ORDINARY MEETING OF COUNCIL

6.3	Subdivision (1 into 2 lots), dwelling & outbuilding located at 183 Back Cam Road, Somerset - SD2144 & DA 215/2021	
Enclosure 1	Consolidated advertised documents.....	2
Enclosure 2	Representation	114
Enclosure 3	Updated bushfire report & plan.....	116
Enclosure 4	Signed extension of time	155
9.1	Declaration of Office	
Enclosure 1	Certificate of Election 2022	156
9.6	Financial Report For the Period Ended 31 October 2022	
Enclosure 1	Monthly Capital Report - October	157
9.7	Senior Management Report	
Enclosure 1	Waratah_Wynyard Request for Finfish Farming Public Forum	164
Enclosure 2	2022/23 Councillor Allowance Payments Information Sheet.....	165
Enclosure 3	2022 11 04 - NRM Response to Request for Public Forum on FinFish Farming	168

SD 2144 & DA 215/2021 183 Back Cam Road SOMERSET

Proposal: Subdivision (1 into 2 lots) & Dwelling and Outbuilding (Shed)

BAL Determination Sheet - Lot 2

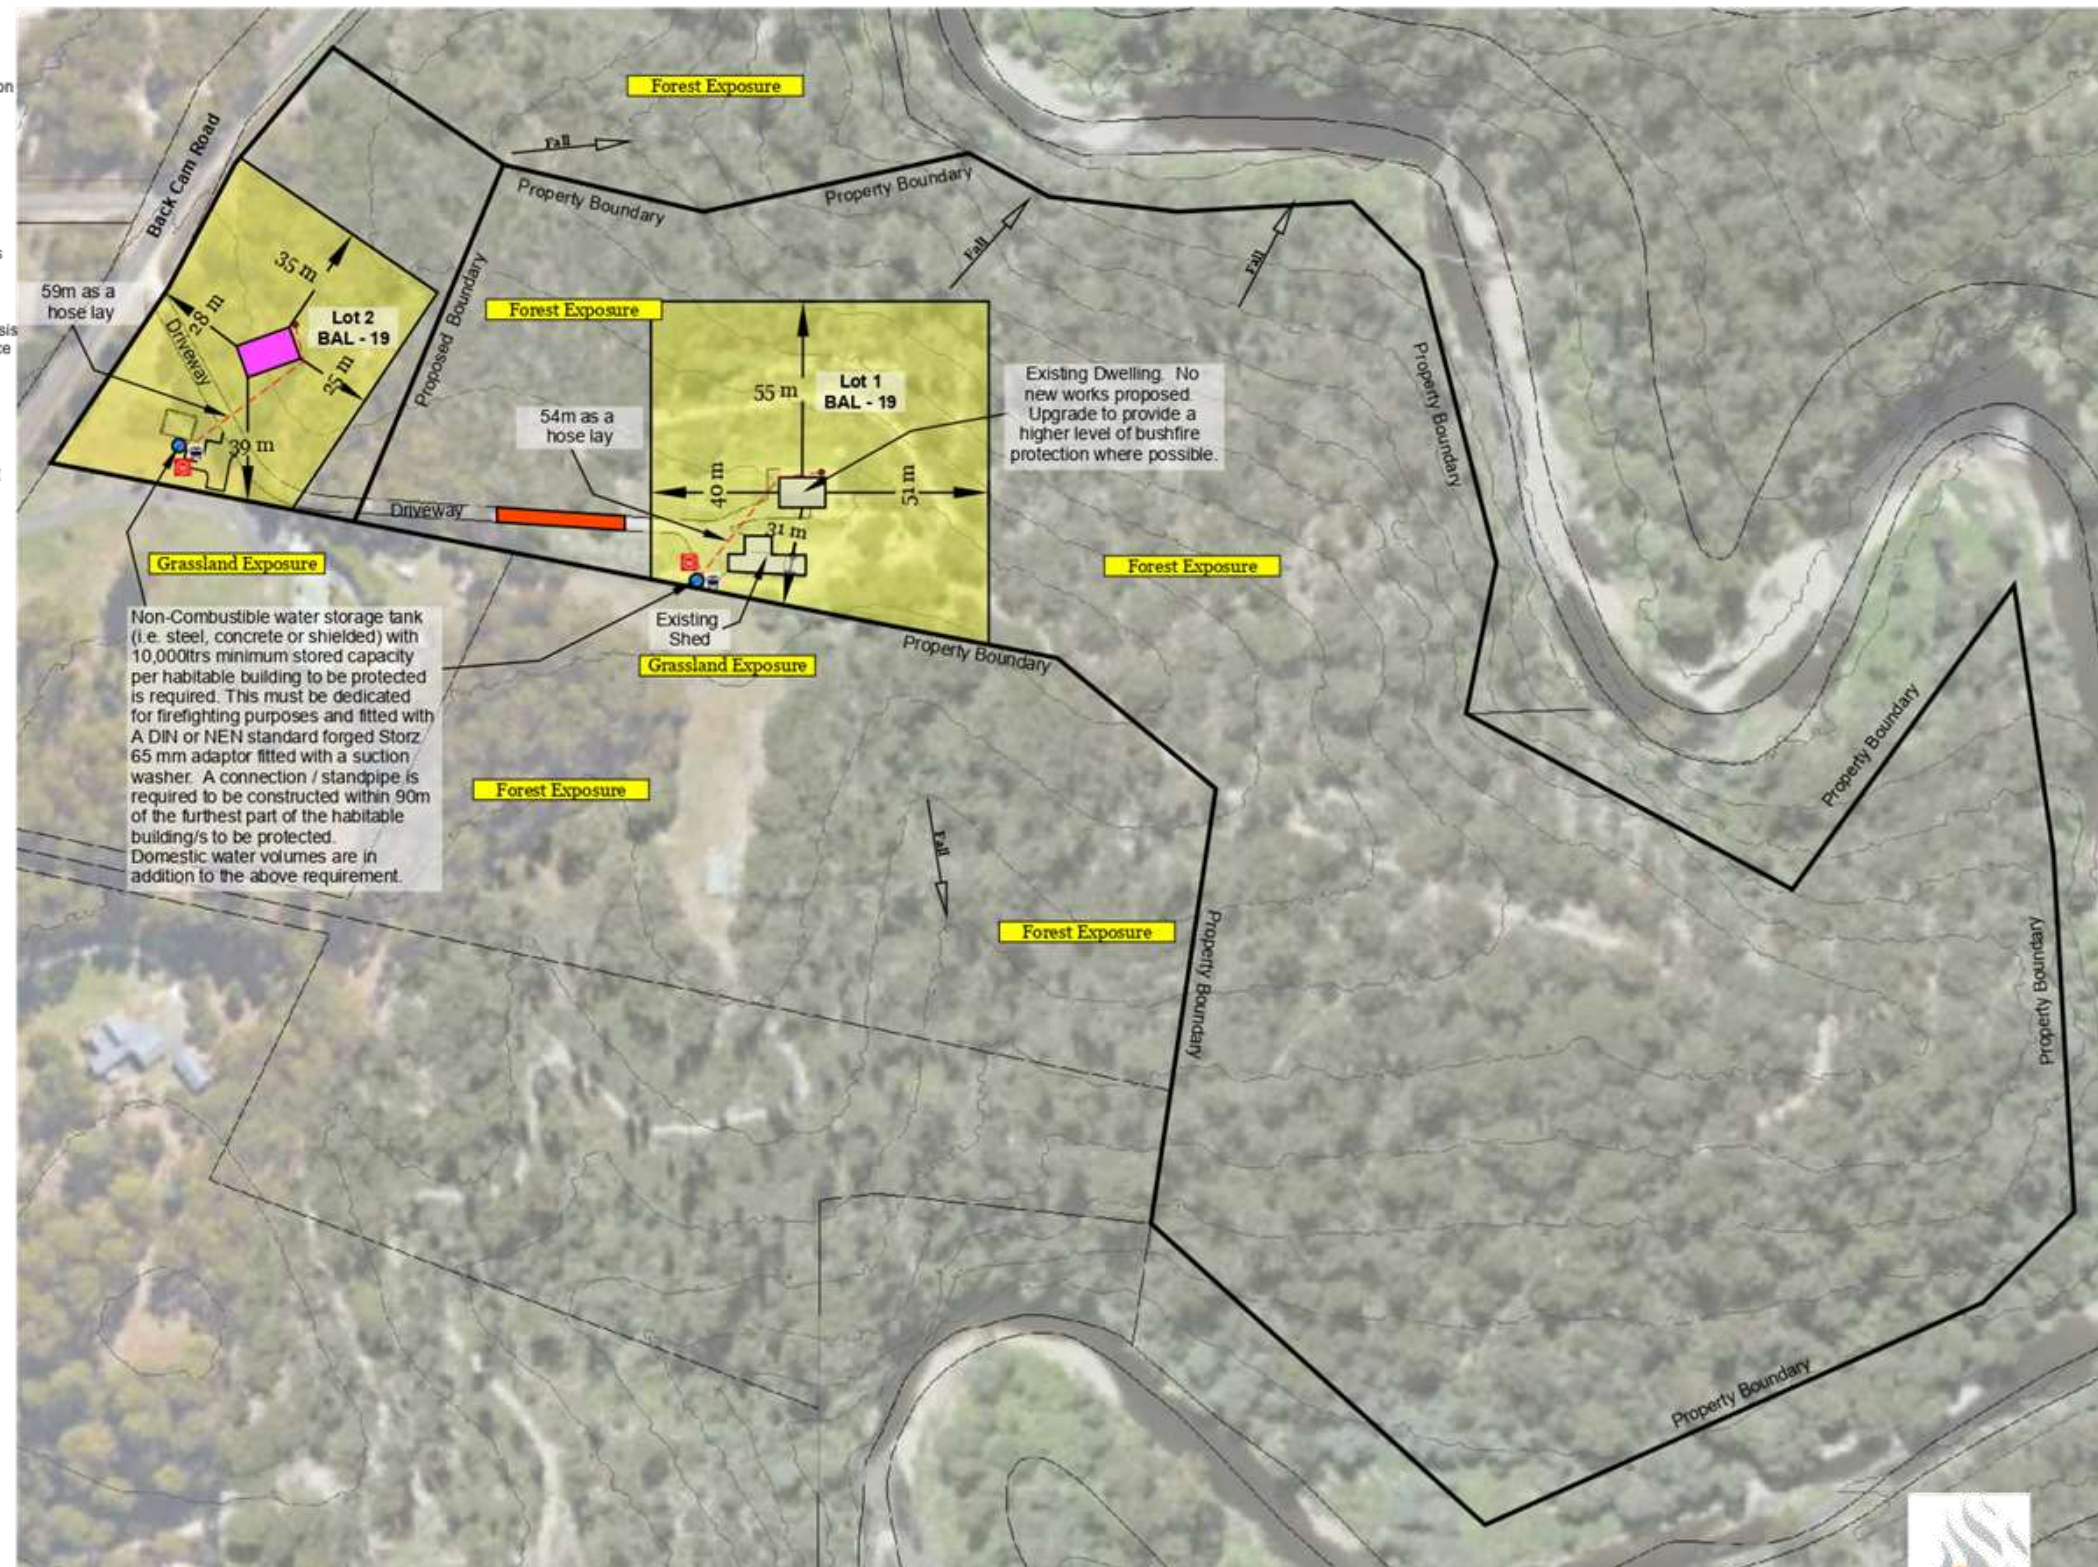
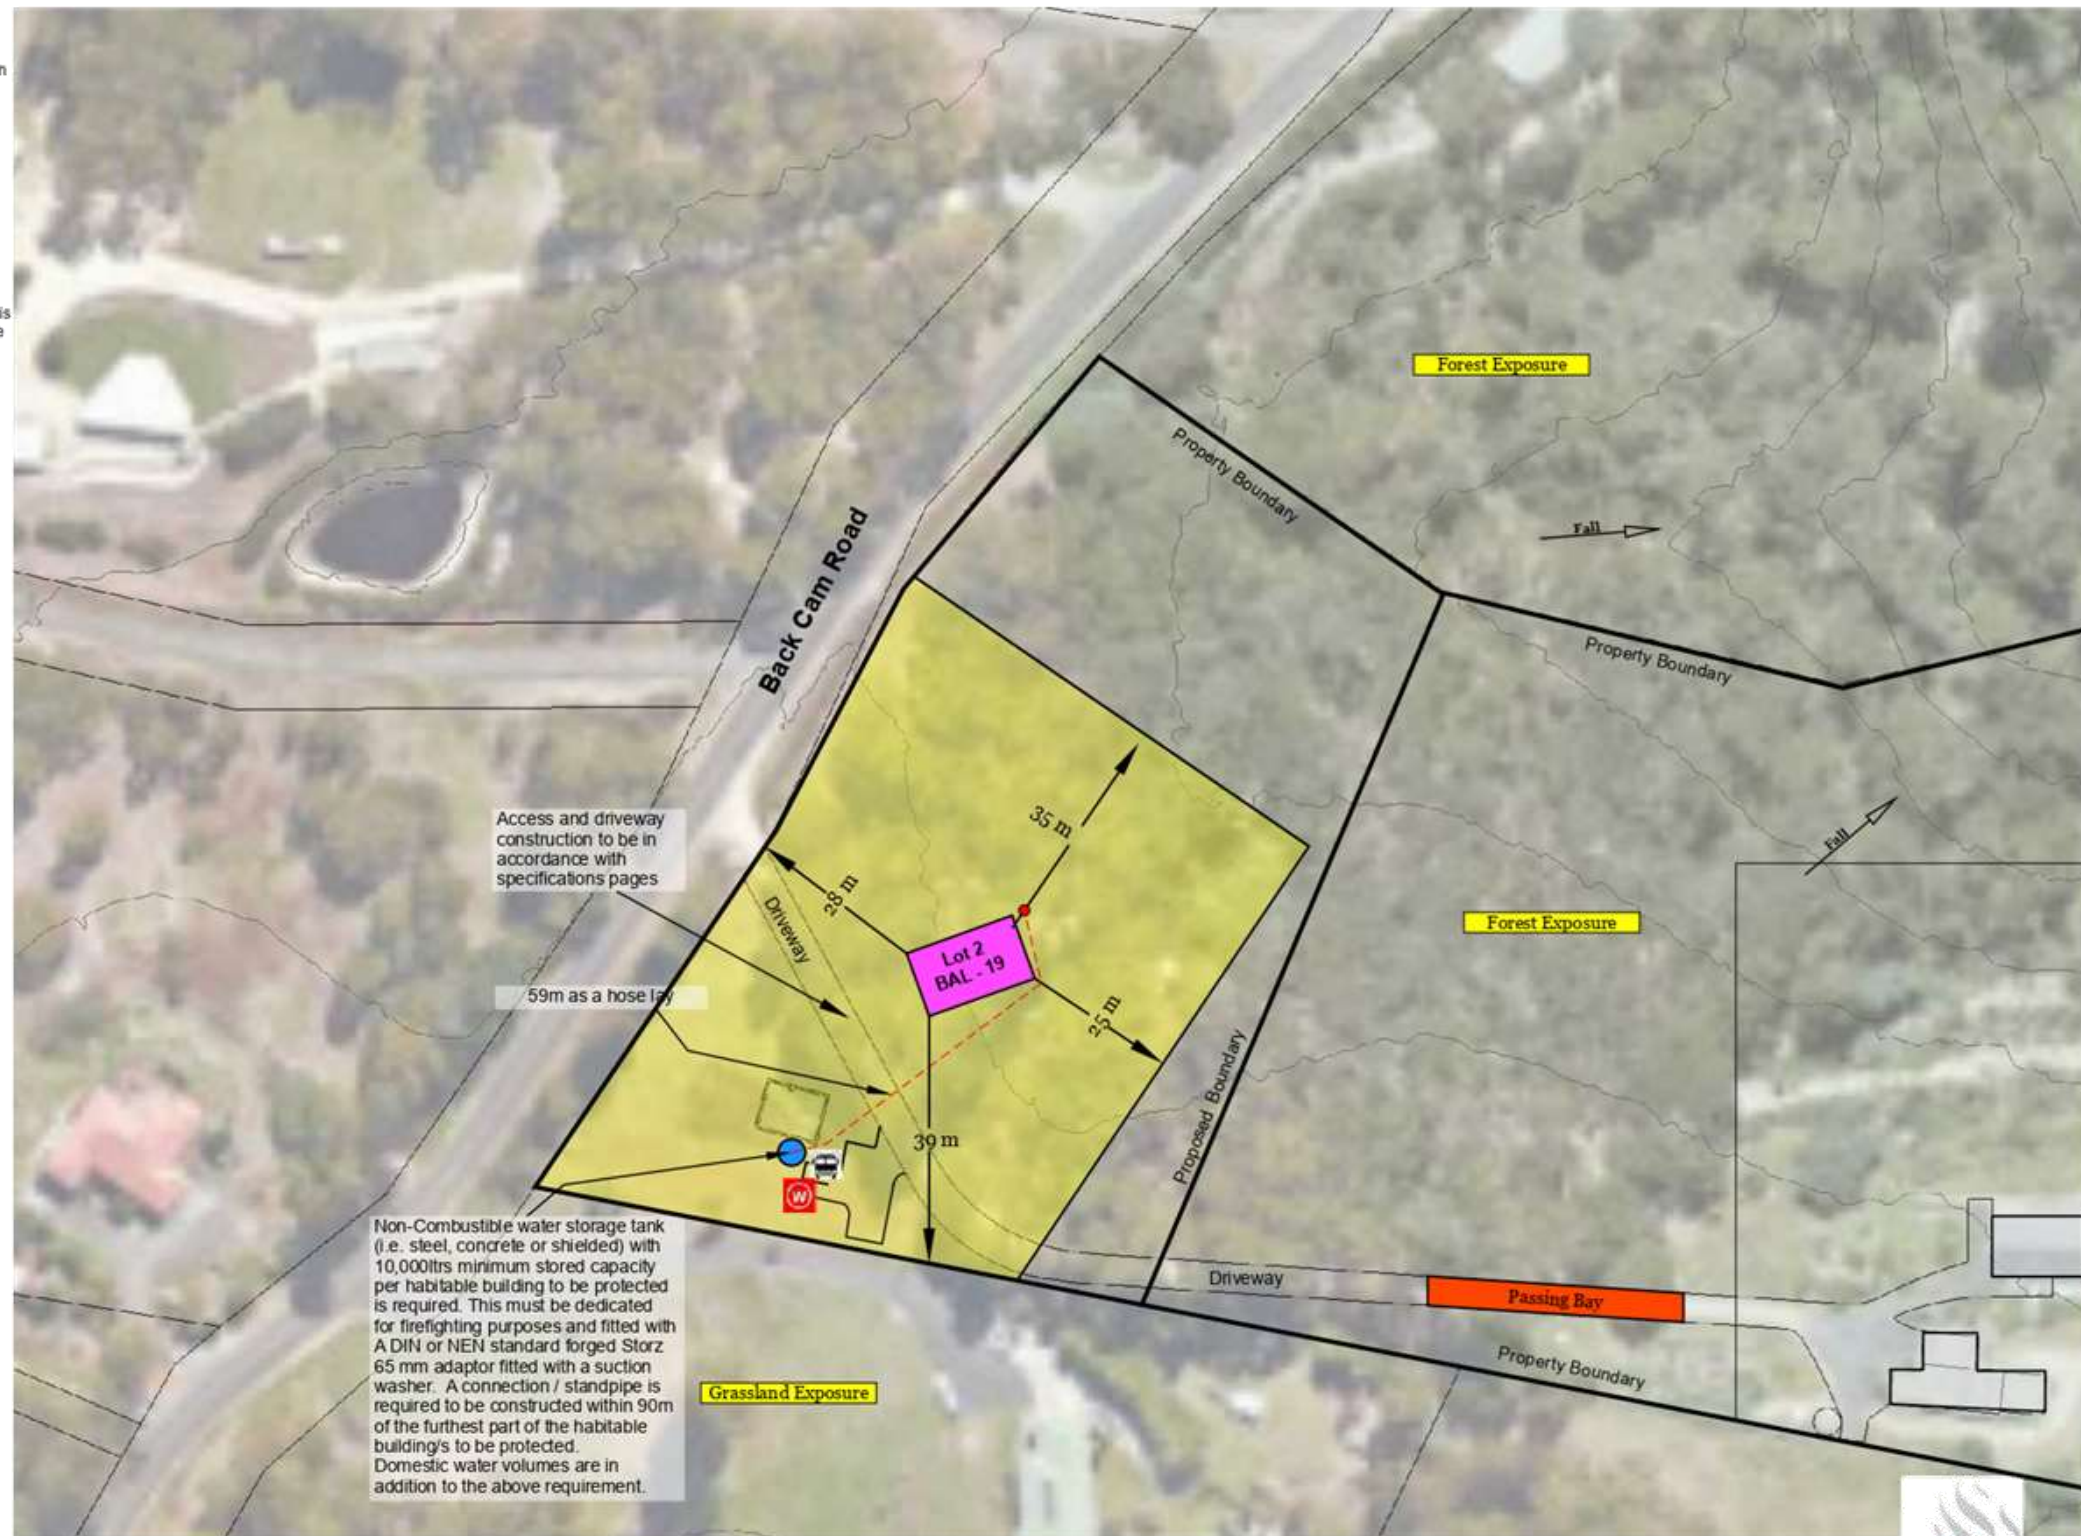
1. E1.6.1 – We believe that the slope assessment is significantly incorrect. The EnviroPlan report assesses the lot 1 slope to north at >10-15 degrees, our TFS assessment has it well in excess of 30 degrees, therefore the hazard management area dimensions are inadequate, not providing for BAL-19 as required by E1.6.1. This is a much greater fire risk to the site and occupants than assessed by the report.
2. As a result of this incorrect assessment, the application doesn't adequately identify the required vegetation removal. The likely true scale of required vegetation removal will be much more than is indicated.
